XA8723A-01

Modification Recommended Service Note

XA8723A IoT Wireless Test Solution Measurement Suite

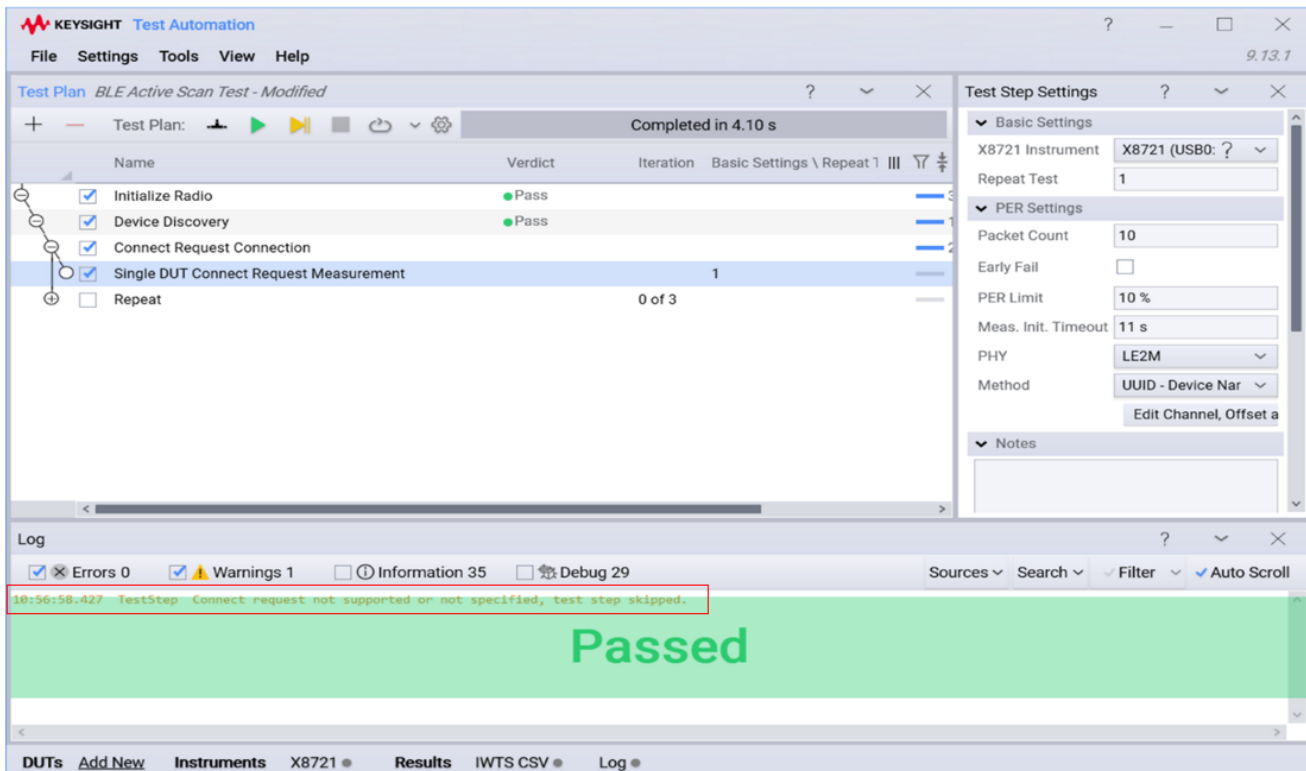
The situation will occur when user configures a test plan which combines Active Scan and Connect Request. This would result in the later Connect Request step being skipped due to invalid pre-condition. A message regarding the mismatch will be indicated as [Connect request not supported or not specified, test step skipped]. However, the csv file will be labelled as Pass as the [Initialize Radio] and [Device Discovery] steps passed the test plan, and this may cause confusion to the user.

Keysight to release a new software version to flag the overall verdict as “Inconclusive” if any of the measurement steps are skipped.

Users are recommended to update the XA8723A Measurement Suite software to version 1.1.23 and above which can be obtained from Keysight.com website using the link below:
